## Access Compliance Report Public Rights-of-Way (Curb Ramps)

Intersection ID: 18029Main Street:E\_WOODLAWN\_RDCross Street:OLD\_WOODS\_RDLocation:SWADA ID: A7C5FC464587Ramp Type:Directional2Initial Pass/Fail:FailOverall Compliance:NoSeverity Score:25

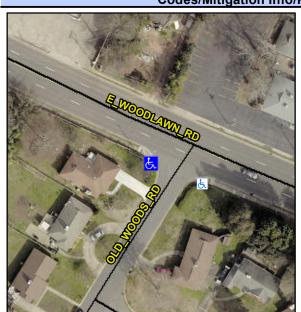
R304.2.2

Compliance Description Data Compliance Description					
N/A			N/A	Grade Break?	Data N/A
Yes	Ramp Length (in)	77.0 57.0	N/A N/A		0.0
	Ramp Width (in)			Grade Break Slope (%)	
No	Ramp Slope (%)	12.5	N/A	Grade Break XSlope (%)	0.0
Yes	Ramp XSlope (%)	0.5			
N/A	Flare Type LT	N/A	N/A	Flare Type RT	N/A
N/A	Flare Slope LT (%)	N/A	N/A	Flare Slope RT (%)	0.0
N/A	Flare Traversable LT?	N/A	N/A	Flare Traversable RT?	N/A
N/A	Landing Length (in)	0.0	N/A	DWS Provided?	N/A
N/A	Landing Width (in)	0.0	N/A	DWS Contrast?	N/A
N/A	Landing Slope (%)	0.0	N/A	DWS Length (in)	N/A
N/A	Landing X Slope (%)	0.0	N/A	DWS Full Width?	N/A
N/A	Landing Curb? (Y/N)	N/A	N/A	DWS Offset LT (in)	N/A
N/A	Shared Landing?	N/A	N/A	DWS Offset RT (in)	N/A
N/A	Gutter Ponding?	0.0	N/A	Gutter Slope (%)	N/A
N/A	Gutter Lip Ht (in)	0.0	N/A	Gutter X Slope (%)	N/A
N/A	Painted X Walk1?	No		Road Slope (%)	1.0
	X Walk 1 Direction	To E		Road X Slope (%)	3.0
	X Walk 1 Width (in)	N/A		Clear Space?	N/A

Remove & Replace Entire Ramp.
